Proposed Floor Plans

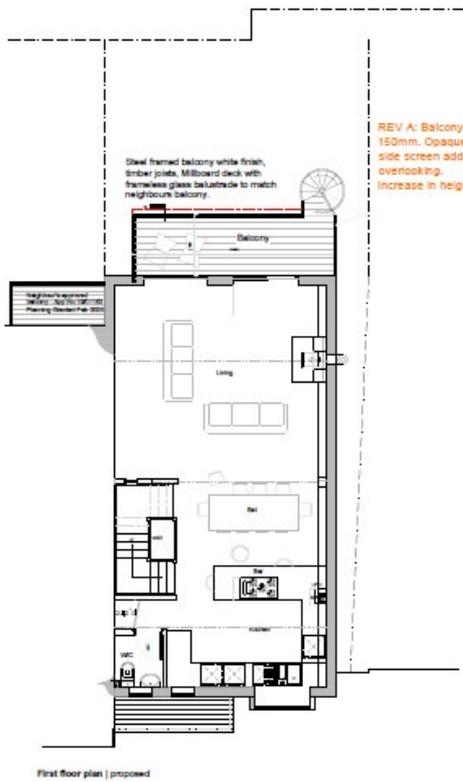
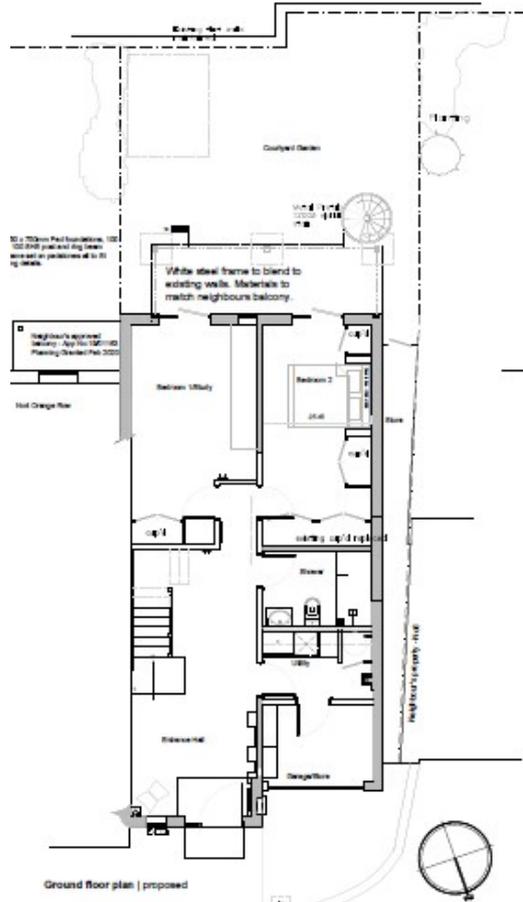
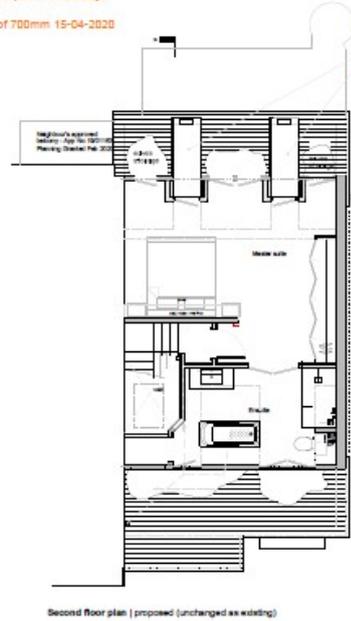
REV A: Balcony reduced in depth by 150mm. Opaque high level (1.8m from FF) side screen added to prevent sideways overlooking.
Increase in height of 700mm 15-04-2020

REV A: Balconettes from 2nd floor removed 15-04-2020. No changes to existing 2nd floor plan.
